Access Compliance Report

Public Rights-of-Way

Intersection ID: 51542	Main Street: GLENBURN_LN	Cross Street: DULNIAN_WY	Location: SW
ADA ID: D2E439C9A662	Ramp Type: BlendTrans1	Initial Pass/Fail: Pass	Overall Compliance: No
		Severity Score: 15

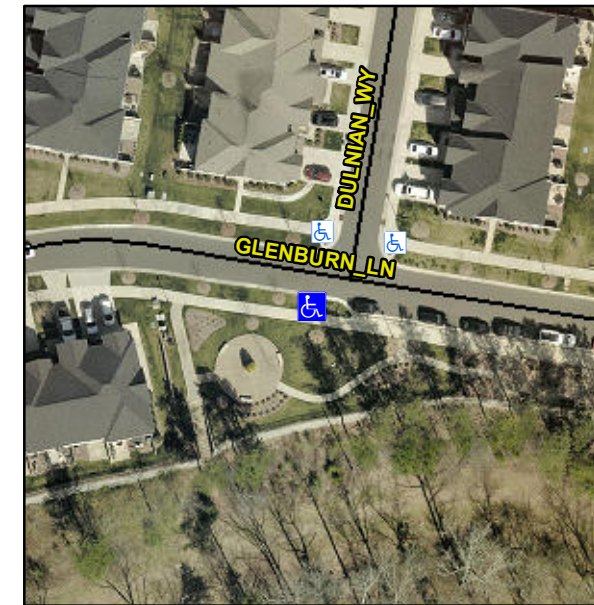
Not Found, R305, R304.5.4

N/A	Ramp inside XWalk1?	N/A	N/A	Ramp inside XWalk2?	N/A
	Road Slope (%)	0.7		Clear Space?	Yes
	Road X Slope (%)	3.1	N/A	Clear Space to XWalk (in)	N/A
Yes	Any Obstructions?	No	Yes	Storm Grate/Utility Hazard?	No
	Obstruction Type			Storm Grate/Utility Type	
		N/A			N/A
			Yes	Surface Condition? (G/P)	Good
			No	Curb Slope (%)	9.0

Remove & Replace Curb Ramp With Two New Directional Ramps or Equivalent. Remove & Replace Gutter.
